442, 450, 454, 462 Wilson Street East, Ancaster Urban Official Plan Amendment (File No. UHOPA-21-023) Zoning By-Law Amendment (File No. ZAC-21-049)

Max. Grade at Stop Roads at Intersections (%)	2.5%	2.5%	2.0%

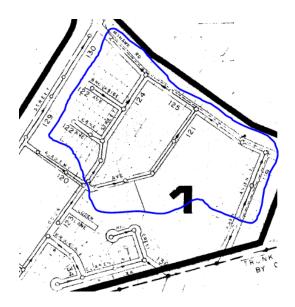
The maximum design grade for a stop street at an intersection is 2.5% but according to City engineering drawings the current grade on Wilson Street East approaching Rousseau from the west is 5.7% which makes stopping difficult under dry conditions, very difficult under wet conditions and hazardous under winter conditions. This intersection is already

hazardous for able bodied-pedestrian crossing; adding seniors with walking aids will be highly problematic.
